City of Alexandria, Virginia

MEMORANDUM

SUBJECT: CONCEPT REVIEW OF 806 NORTH COLUMBUS STREET

BAR CASE # 2025-00373

Figure 3: Proposed front and rear elevations

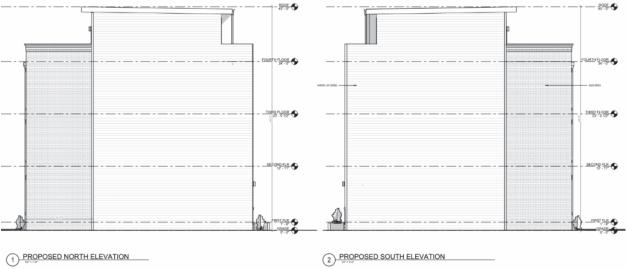
The proposed townhouses will be clad in a combination of brick and fiber cement siding (Figures 3&4). The two outer townhouses will be 18'-3" wide and feature a projecting bay of three punched windows with the entry door located in the recessed section of the façade. The center townhouse will be 16'-0" wide with a projecting bay of two punched windows and the entry door below punched windows in the recessed section. The street facing elevation of the fourth floor will include operable glazed doors and a transom. The front portion of the building will be clad in brick with the transition to fiber cement siding occurring on the sides aligned with the set back fourth floor. This siding will encompass the fourth floor and the rear of the building. At the rear of each townhouse, the fourth floor will be set back 3'-6" from the lower floors and will include simple glazed doors. A grouping of three punched windows will be located at the second and third floors above an operable glazed door at the ground floor.

The proposal includes elevations for the visible portions of the exterior; however as it is early in the design process there remains a greater level of detail and three dimensional views to be produced. The buildings will be clad in brick at the street facing elevation and this brick will extend across a portion of the long elevation to align with the front of the set back portion of the fourth floor. The street facing façade will be dominated by punched window openings at the second and third floors and a large, ganged window at the ground floor. Staff finds the use of brick transitioning to fiber cement siding to be compatible with the nearby structures. The use of punched windows is similar to windows found on historic structures; however the solid to void ratio of the proposed design includes more glazed areas than typically found on historic buildings.

The rear of the buildings will be visible from the adjacent public right of way and is therefore under the purview of the BAR. These elevations are clad in fiber cement siding with a central three bay wide ganged window on each floor above a similar door at the ground level. At the fourth floor of each building is a set back massing and roof terrace. The drawings seem to indicate windows facing these roof terraces but presumably some of these will be doors providing access to the terrace. While it is typical for the rear elevations of townhouses to be more simple than the primary elevation, staff finds that given the high level of visibility of this portion of the building, the window composition could be more decorative than currently submitted.

- Examine the amount and spacing of windows on the front façade to be compatible with the solid to void ratio typically found on structures in the historic district.
- The proposed windows on the front façade use a four over four lite configuration. This configuration is not typically found in the historic district. The applicant should consider alternate lite configurations.
- The submission shows a brick base at the front façade, a stone base at the rear and no base at the side. A singular base detail should be developed to tie the different portions of the building together.
- Corner boards are inconsistently shown at the corners of the fiber cement siding. This detail should be further refined.
